Issued Thursday, October 13, 2022.

ADDENDUM

Project: Community Hall Additions and Renovations, Milton, PEI

DRAWING FIRE ESCAPE PLAN LAYOUT	AR-SK#1	COMMUNITY HALL ADDITION & RENOVATIONS MILTON, P.E.I. WDL W.D. LAWRENCE ARCHITECTURE INC.
SCALE AS NOTED	REFERENCE DRAWINGS: A-3	OCT. 12, 2022 DWG 1 of 3

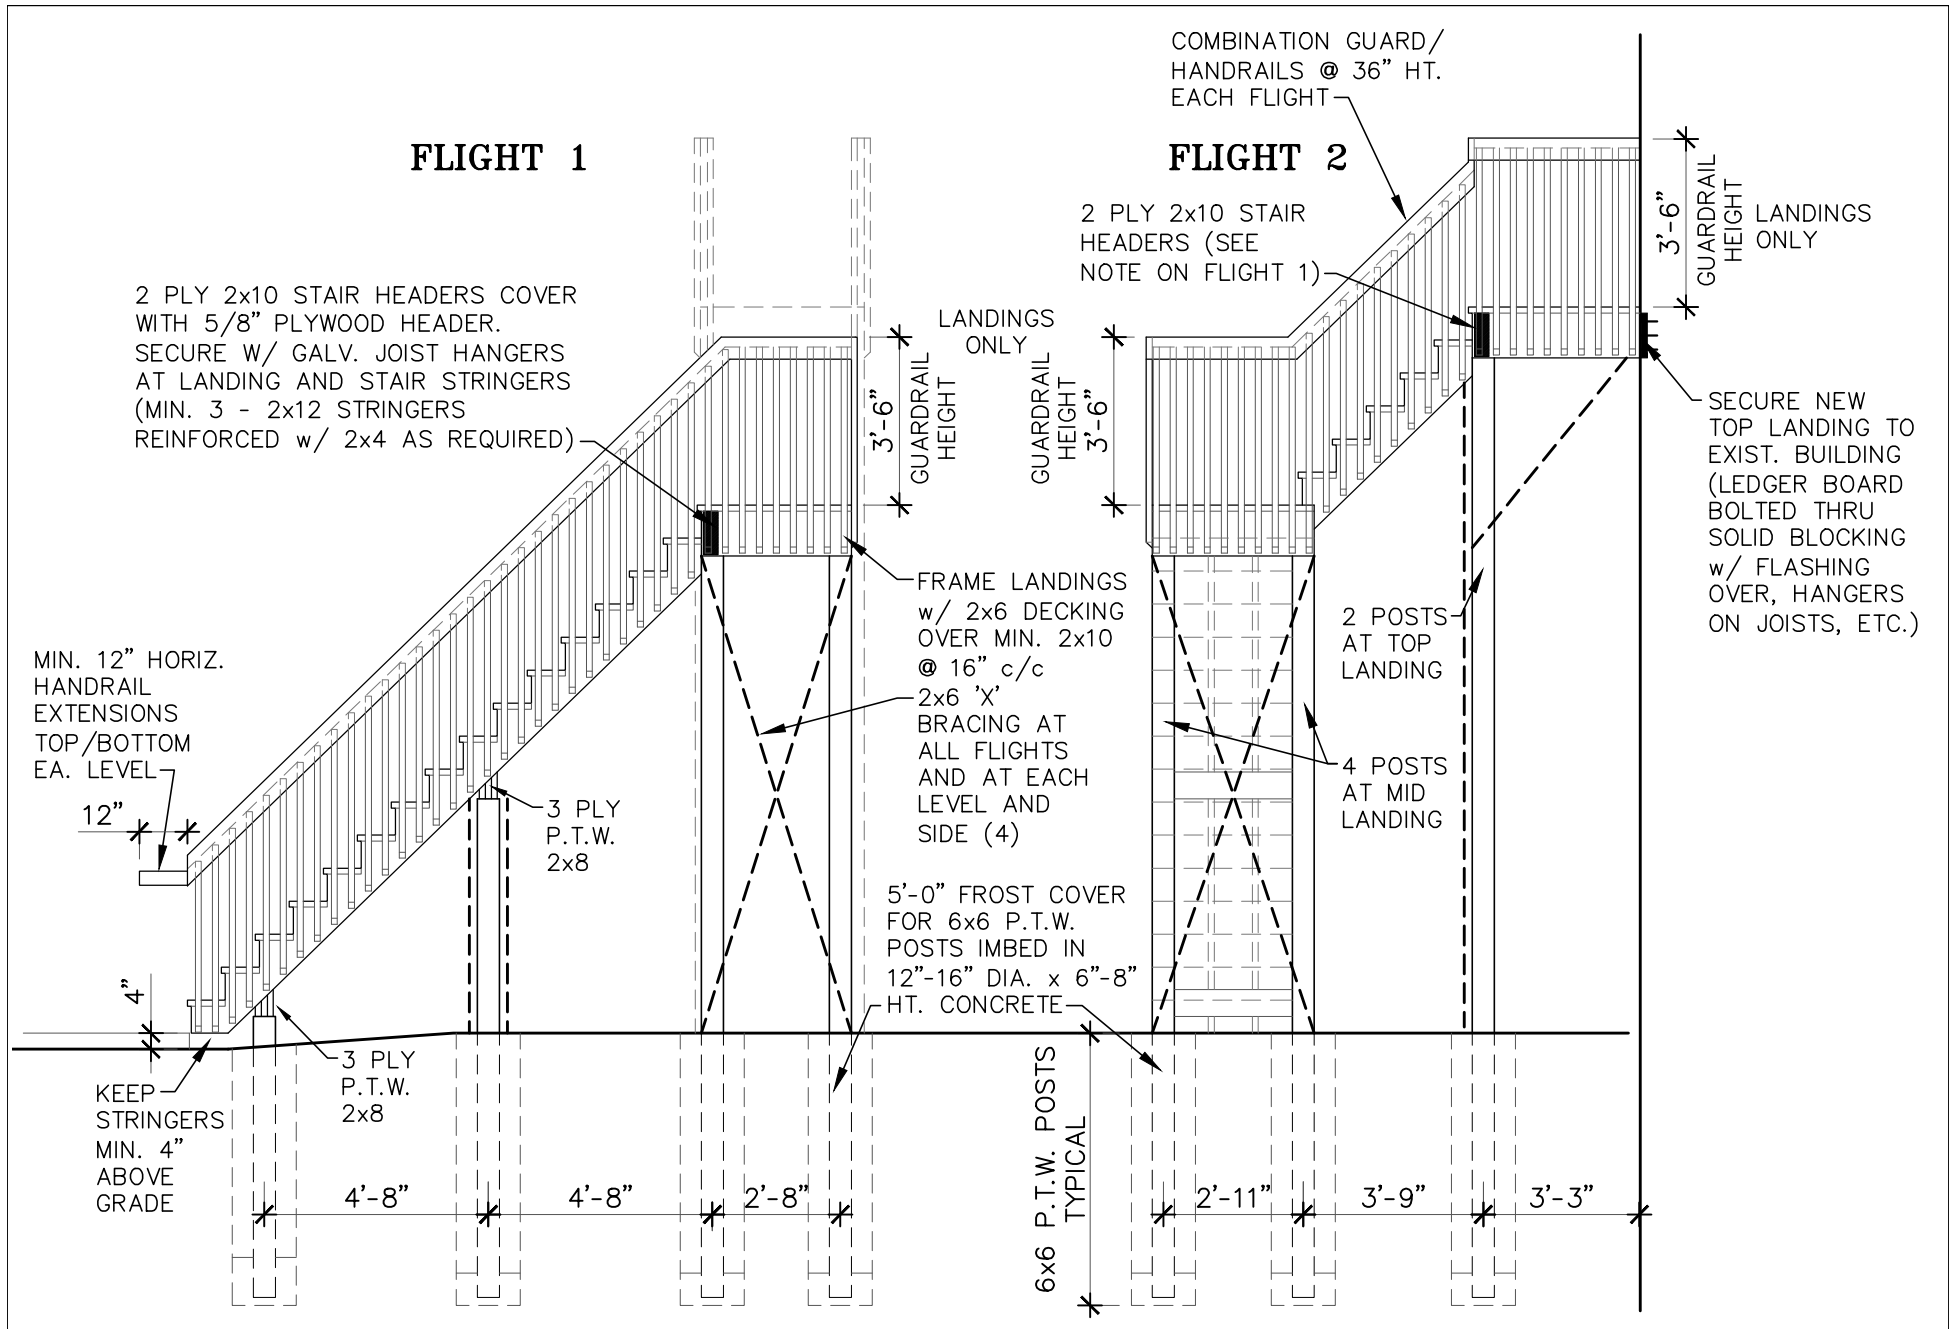
1. Refer to attached Dwgs. AR-SK#1, #2 and #3 for fire escape which is included in scope of work for this Project.
2. Please include attached Changes to the Drawings Page 1 of 1, 2022-10-13 from Orange Door Engineering.
3. Electrical to note that as per this Addendum from M103 item d. that in the second level Boardroom, IDU-X shall be removed and relocated.

NOTE: KEEP
 BOTTOM POSTS
 BACK 3 RISERS
 SO BOTTOM
 RISER 'FLOATS'
 4" ABOVE
 GRADE

EXTEND
 HANDRAILS
 12" HORIZ.
 EACH SIDE

3 PLY 2x8 P.T.W. STRINGER
 SUPPORT BEAM AT CENTRE
 OF FLIGHT 1 AND ALSO AT
 3 RISERS FROM GROUND
 (TO FLOAT FIRST RISER
 ABOVE GROUND)
